California Energy Commission
Dockets Office, MS-4
Re: Docket No 10-BTSTD-01
1516 Ninth Street
Sacramento, CA, 95814-5512

Carrier Corporation, a division of United Technologies has review the proposed language posted on the CEC web page as of Oct 24, 2011 and would like to file the following comments and proposed changes.

**FAN CONTROL AND INTEGRATED
ECONOMIZER TITLE 24 PROPOSAL
CARRIER COMMENTS**

Economizer Cycling

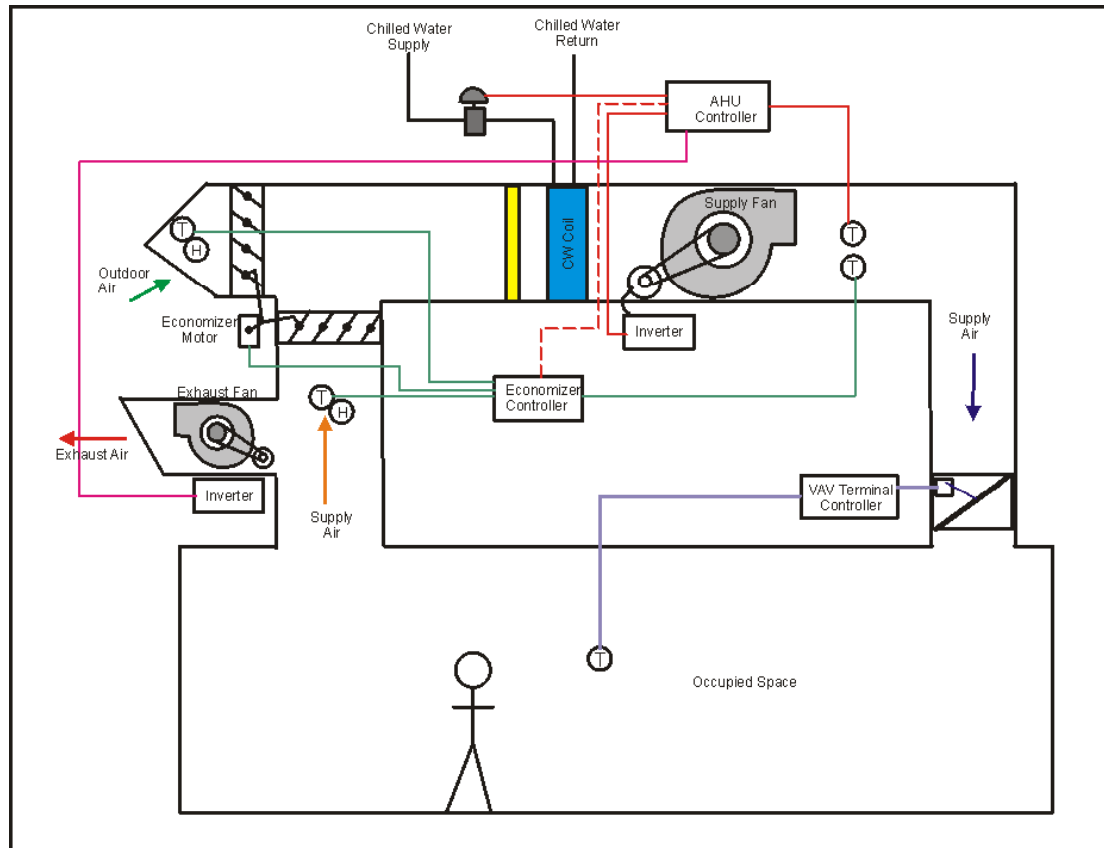
- In the Title 24 justification document dated September 2011 and the ASHRAE 90.1 October 2011 justification for the integrated economizer proposal a plot of cycling problems with an economizer was documented and this is driving the proposal for capacity modulation down to 20% actual capacity

- The unit in question was a VAV unit and already had capacity control down to 25%
- Extending capacity control down to 20% as proposed will not solve the problem.

- The problem with this unit is that the economizer and capacity control are controlling to the same temperature sensor, but appear not to be link in software which results in one overriding the other and causing the cycling

- What would solve the problem is linking the economizer and compressor control such that the dampers are locked open during integrated compressor operation. In fact the manufacturer of this unit agrees a change is needed and they are working on new logic.

Figure 2 – AC Unit Control – M5 AC-2.2C

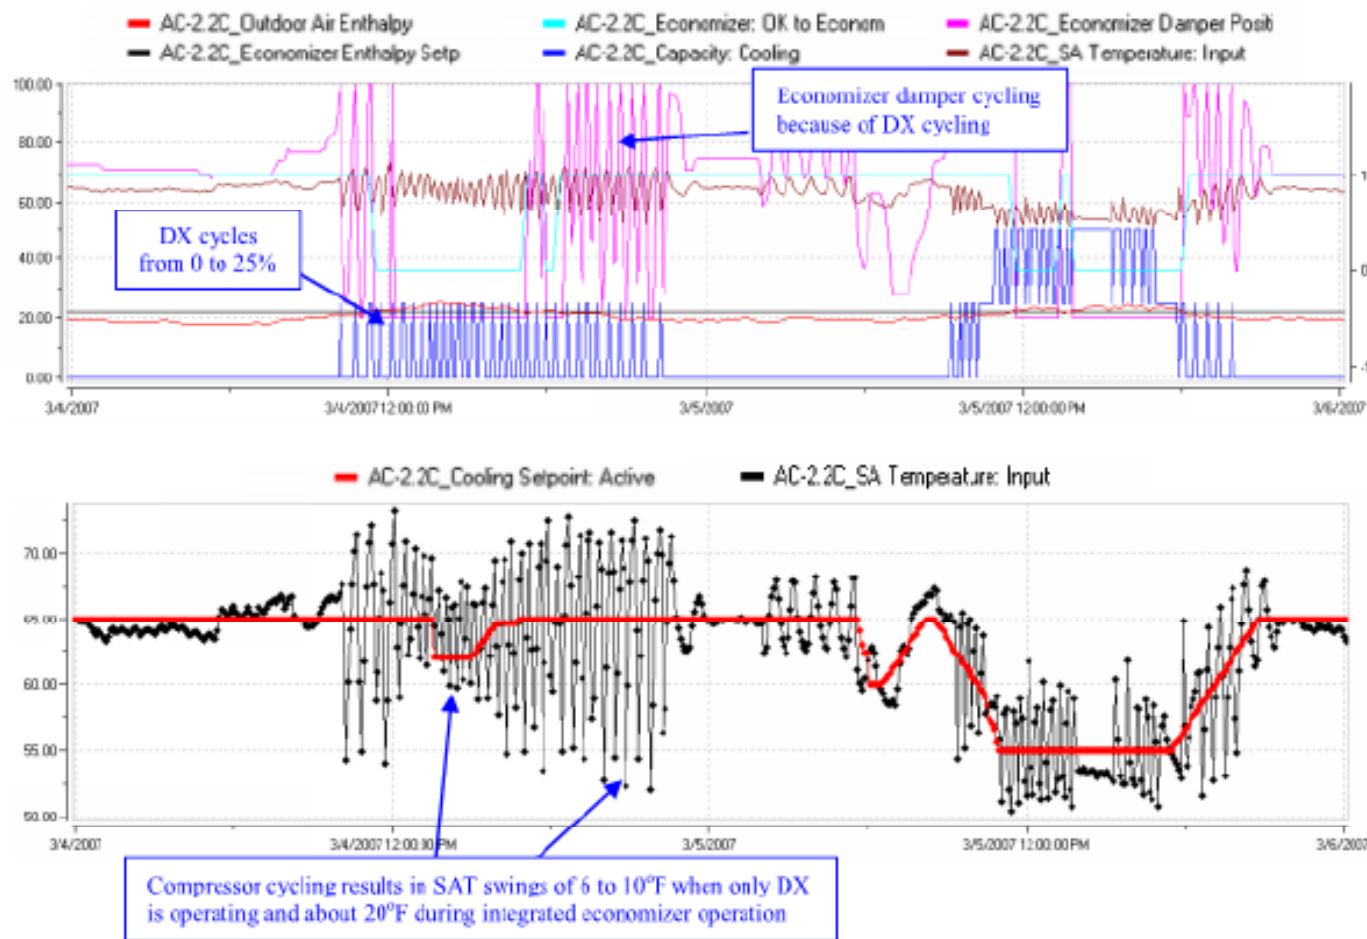
This is a referenced justification temperature trace from a VAV units that had a minimum capacity step of 25% where the dampers and compressor were fighting each other

This is a VAV units that already has 4 stages of capacity and just dropping the capacity control to 20% from 25% will not solve the problem. It require controls changes

Typical 5 Ton Single Stage Rooftop

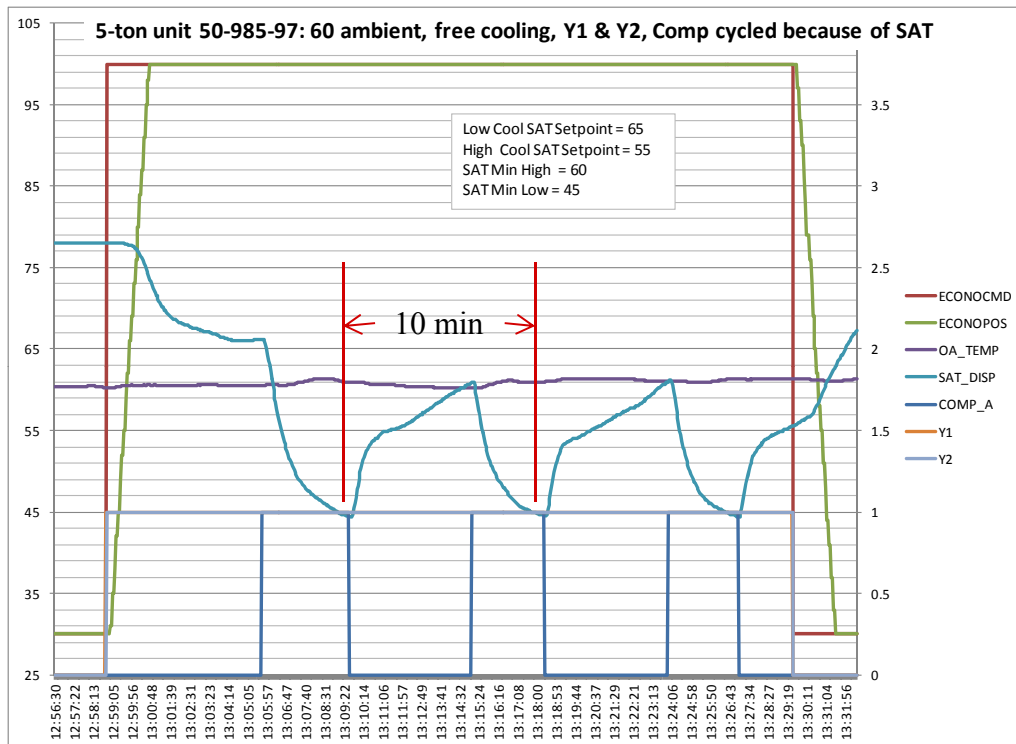
This is a trace from an actual Carrier 5 ton unit with a single compressor where the dampers are locked open and the compressor cycles on and off at duty cycle of around 10 minutes. There is degradation in performance due to the lower suctions and cycling but this was reflected in the original ASHRAE 90.1 economizer analysis and is significantly less than the assume used for the Title 24 and ASHRAE justification which assume a 25% loss in all economizer operation

Addition of two stages of capacity will further improve this and many of the units already have two mechanical stages

This the worst case with a single compressor but it shows with proper controls that the full benefit of the economizer is obtained

Real Compressor Efficiency Curve

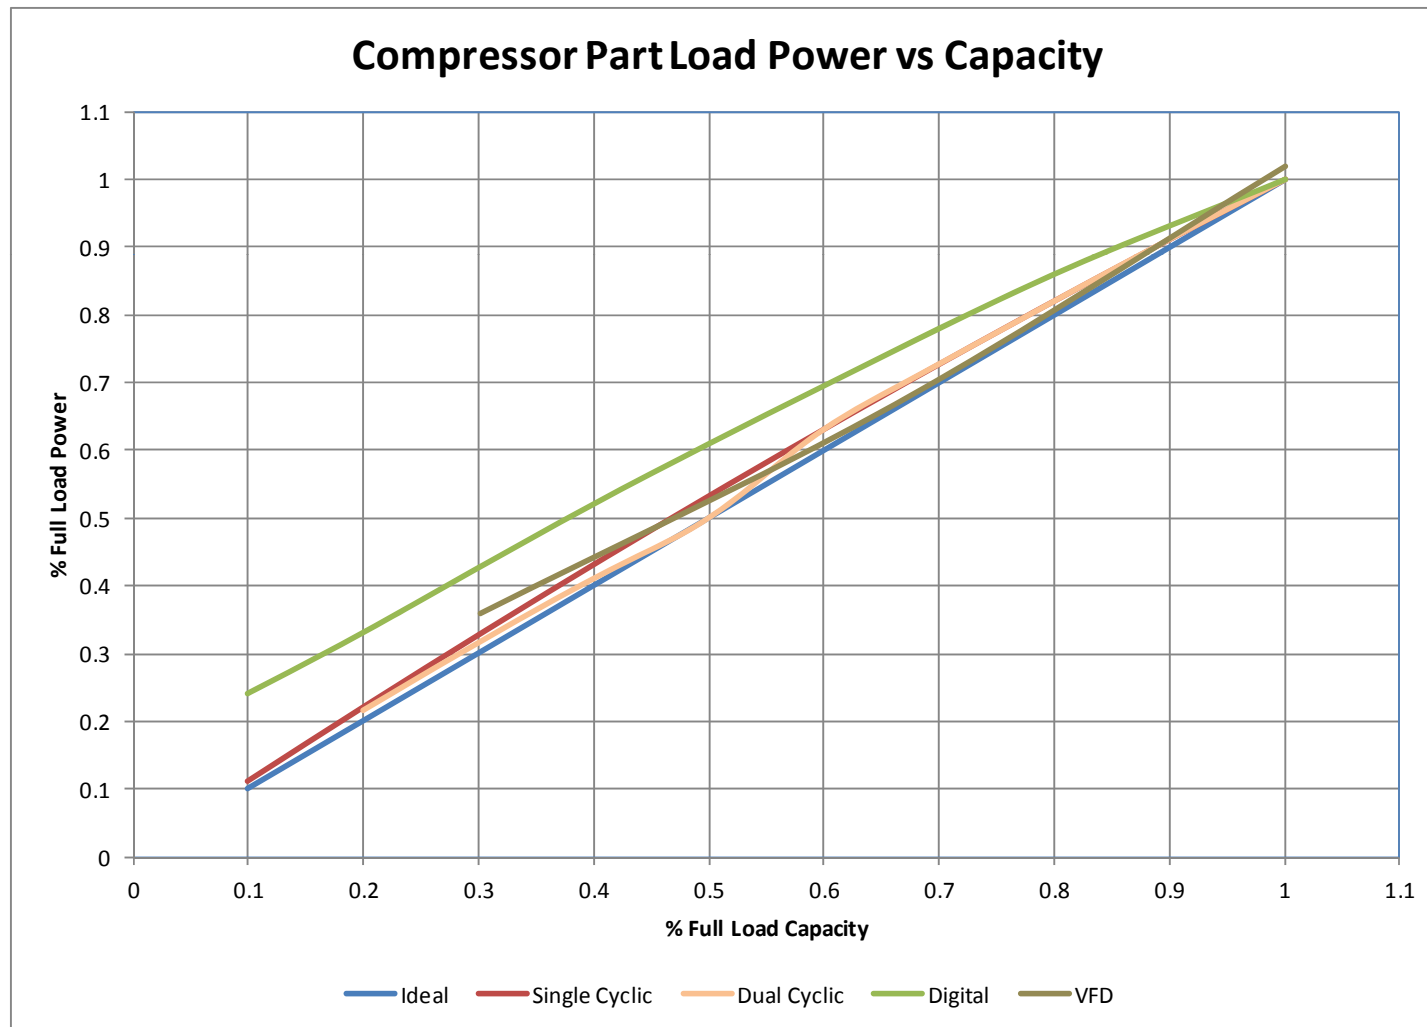
- In one of the referenced papers a plot was shown that indicated variable speed compressors are significantly better at reduced load. **This curve is totally wrong.**

This curve is saying that at part loads the compressor power is constant which is wrong. A single compressor will cycle and the power will be the integrated sum of the on-off power plus a degradation factor for startup

This is a correct plot of the % full load compressor power vs the full load % capacity at a constant saturated suction and saturated discharge

Alternate Compressor Plot

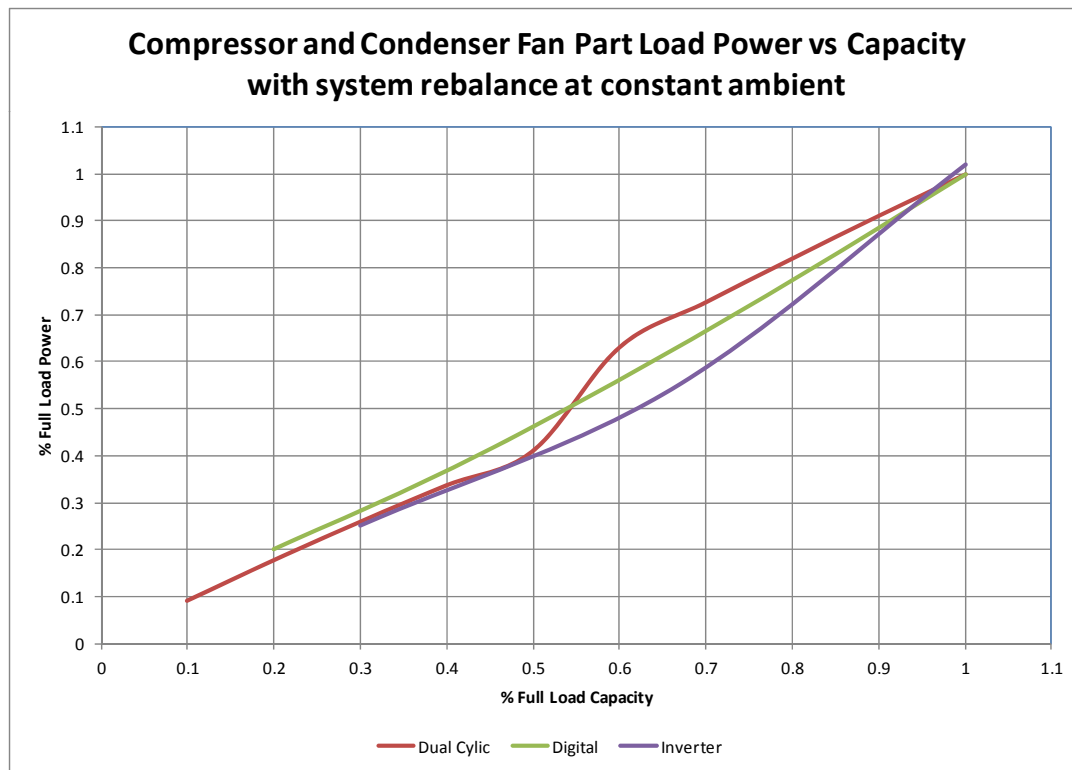
- The prior plot is misleading as it is only a compressor plot and does not factor in the rebalance of the heat exchangers as they unload in a real system.
- I created a plot of various compressor options to show what a real system impact would be.
- This is a plot of compressor and condenser fan power at a fixed ambient and return air condition

The huge performance improvement is not there and dual compressors on a single circuit perform better than a digital and close to that of a full variable speed with much lower complexity

This is actual confirmed in that most who use the digital have to limit the capacity unloading to get a good SEER

Also note that the variable speed can only get done to 30% and the requirements is 20% which is more like 15% displacement which would require dual compressors.

Figure 5. Combined Measures: Fan Control and Integrated Economizer – Single Zone DX:
% design fan speed versus % design cooling load for a representative zone

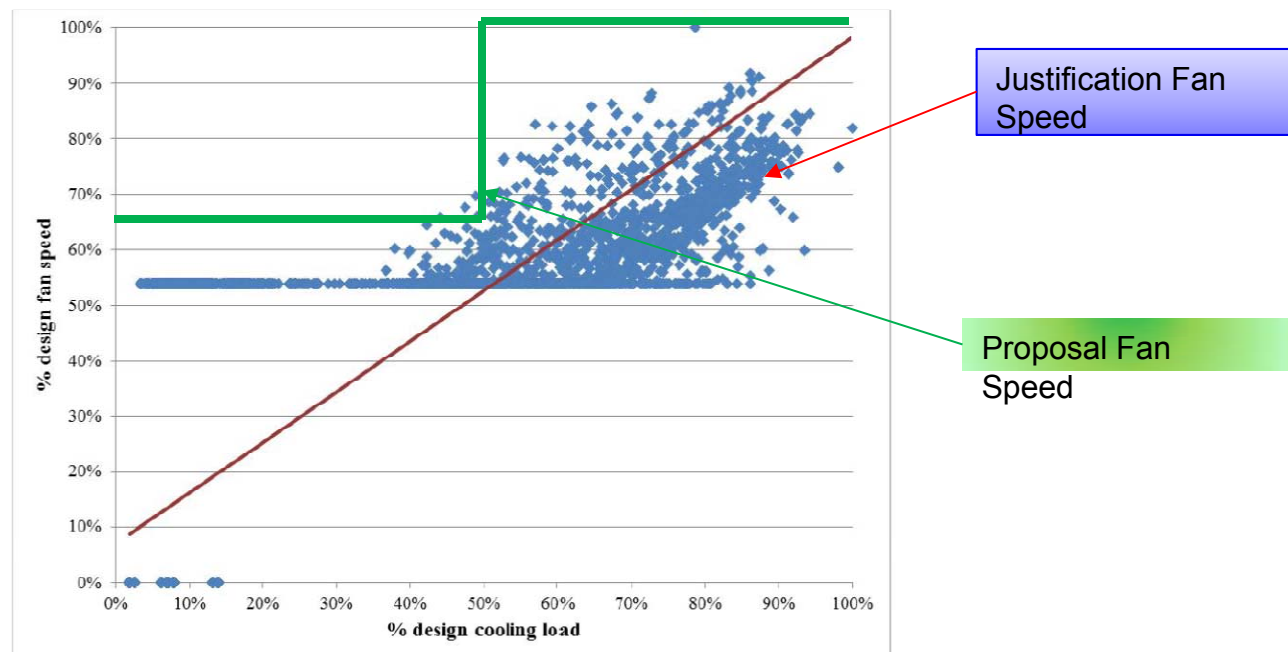
- The proposal requires for DX products a fan speed of 66% below a load of 50%
- For ASHRAE 901. The justification document assumed Variable speed fans starting at 100% load down to a speed of 50% at 50% load
- This would indicate the savings might be overstated, but the proposal also assumed very high fan and motor efficiencies and reduced the savings. In our analysis we actual found the savings are greater
